Delegated Report		Analysis sheet		Expiry Date: 25/09/2024	
		N/A		Consultation Expiry Date: 07/09/2024	
Officer			Application Number(s)		
Ewan Campbell			2024/3200/P		
Application Address			Drawing Numbers		
34 Chalk Farm Road London NW1 8AJ			Please refer to draft decision notice		
PO 3/4	Area Team Signature	C&UD	Authorised Officer Signature		
Proposal(s)					
Erection of lower ground and ground floor extension to form new fire exit. Associated facade works.					
Recommendation(s):		Refuse Planning Permission			
Application Type:		Refuse Planning Permission			
Conditions or Reasons for Refusal:		Refer to Draft Decision Notice			
Informatives:					
Consultations					
		No. of responses	00	No. of objections	00
Neighbour Consultation		A site notice was put up on 14/08/2024 and expired on 07/09/2024 No comments have been received by neighbours			
Site Description					
The application site comprises a four-storey building with basement to the rear of the buildings on Chalk Farm Road and along Harmood Street. The use is as a student accommodation with rooms contained within the building. The area is mixed with commercial along Chalk Farm Road but with mostly residential to the northern

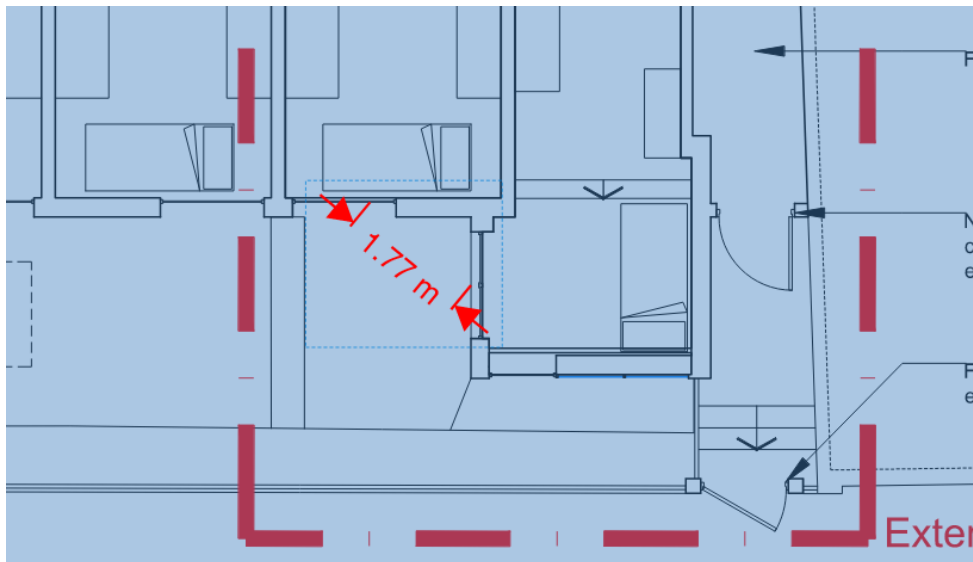
- 3.1.2. The original building is a contemporary design along Harwood Street with punched windows, orange metallic cladding and protruding green window boxes placed on the elevation. The upper floor is completely glazed. Whilst this building may not be hugely positive, there is an overarching design which is clear and follows a pattern.

- 3.1.3. The scheme would involve removing the southernmost window box and replacing it with two storey extension which is of similar appearance. The window boxes would all protrude the same amount (0.9m) however this extension would extend to 2.2m. This creates an awkward relationship with the rest of the building and means the extension appears incongruous in this context. The fact that it drops down also means is at odds with the whole building and reduces the overall appearance of the building itself. It is noted that a green roof is proposed which is positive in relation to the biodiversity however does not overcome the principle of the development the overriding concerns the council has.

- 3.1.4. The proposal also includes the formation of a new entrance/exit and fire exit with alterations to the railings to form a gate. As per policy D1 above the Council aim to provide design which encourage safety and security and encourage developers to consider these issues. In this instance an new exit is being forced in this part of the building and creates a hidden corner which would increase the chance for crime and antisocial behaviour due to the limited visibility. It is also noted that the fire escape itself has steps due to the level change and therefore is not accessible and has not considered how disabled occupants would leave the building in the event of the fire. Both these elements are very concerning and not something the Council can support, conflicting with policy D1 and also C5 which aims to make Camden a safer place.

- 3.1.5. The Council also notes that there are several inaccuracies with the drawings; the height of the window boxes are incorrect and the highest ones are slightly smaller which is not picked up on the elevation drawings.
